Item No. 9.1.1
Design Review Committee
March 25, 2019

SUBJECT: **Case 22254: Substantive Site Plan Approval - 5640 Sackville Street and
1577 South Park Street, Halifax**

Attachment C – Design Manual Checklist: Case 22254

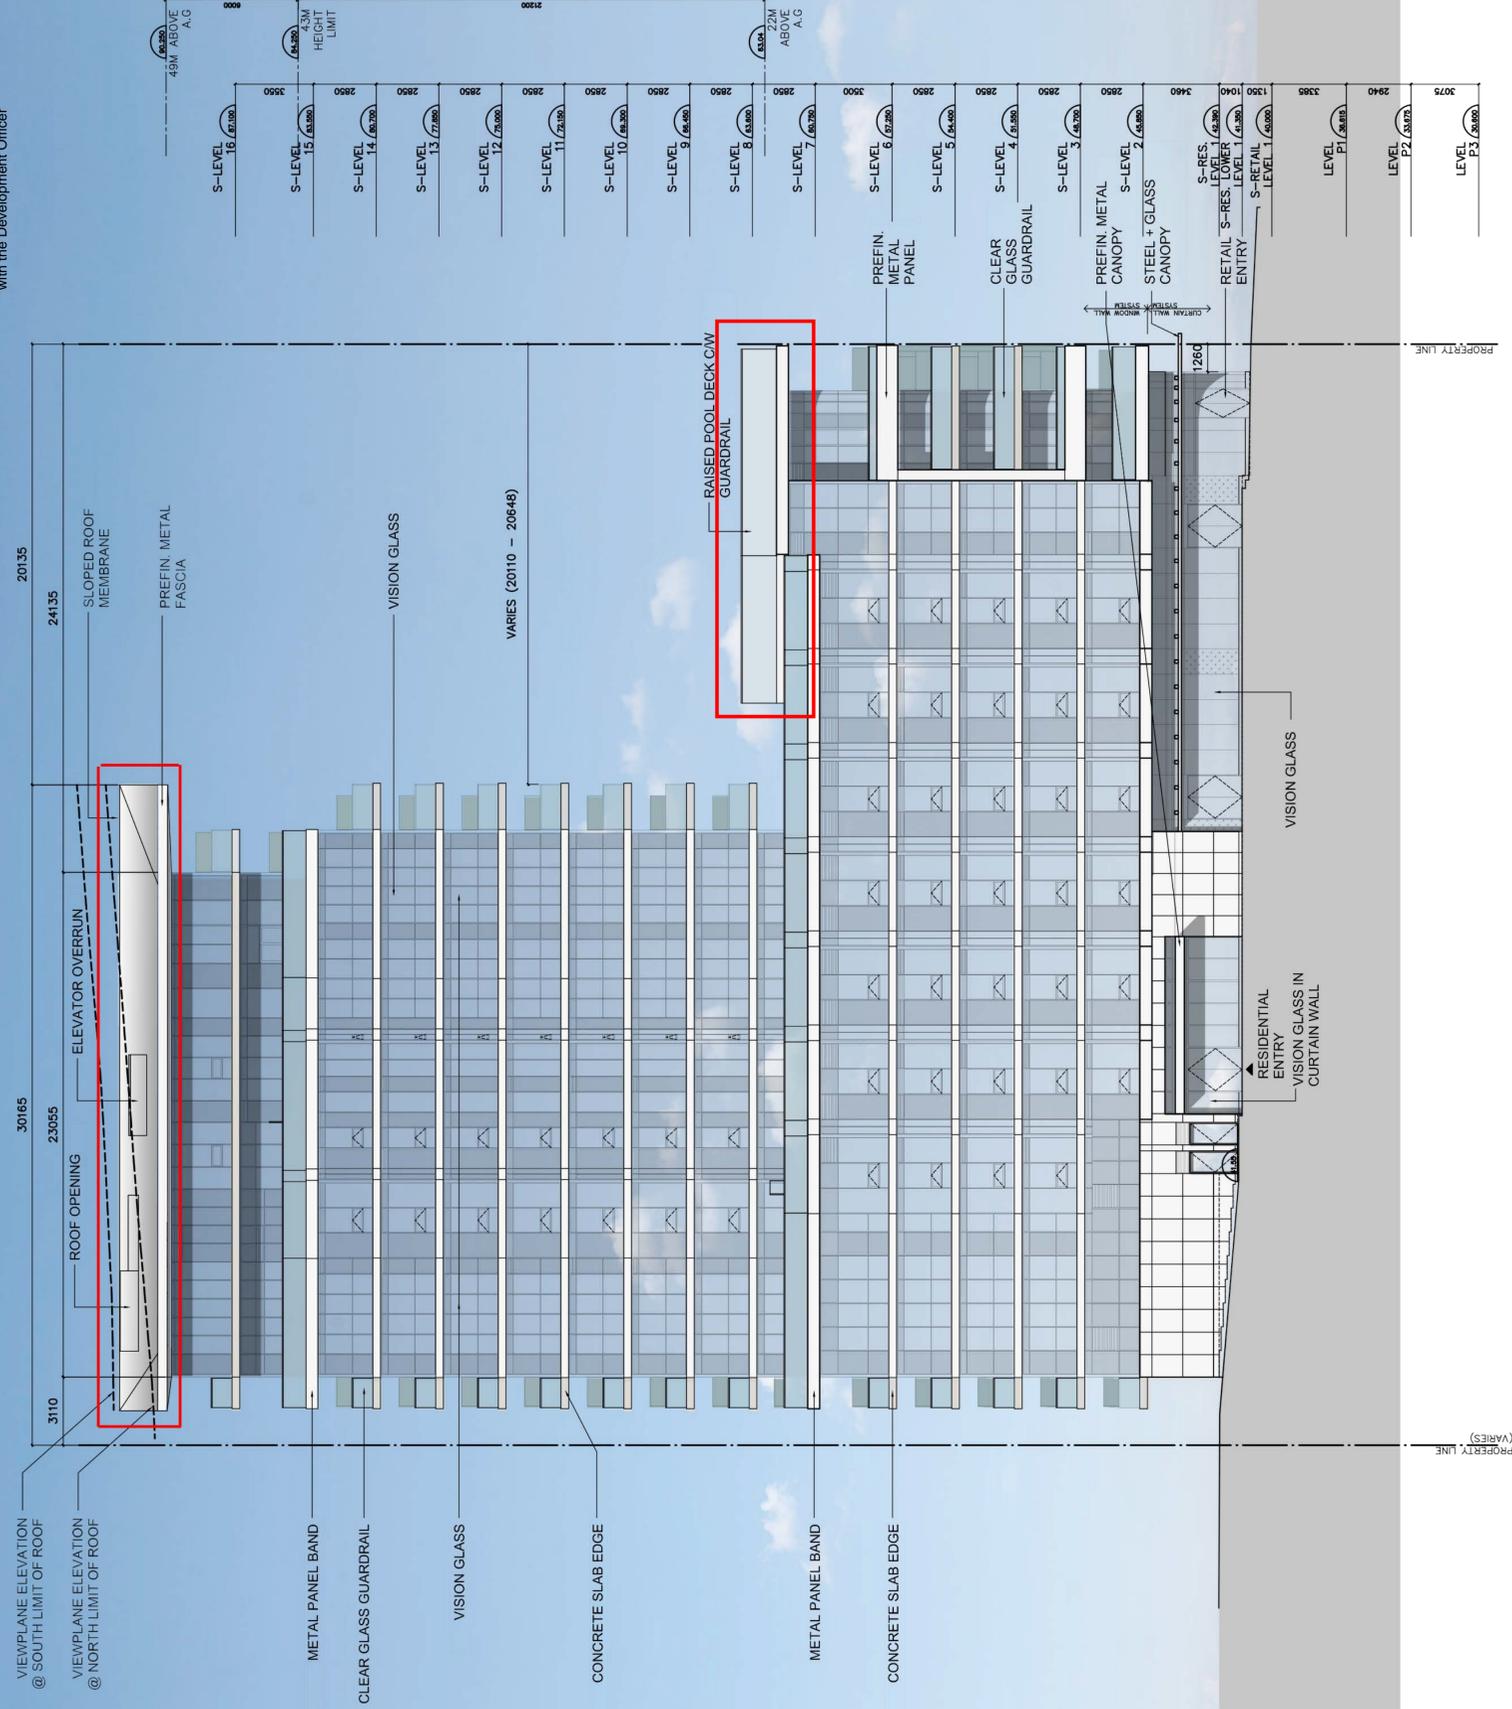
Architectural feature at Curve's 7th floor terrace to be developed in consultation with the Development Officer
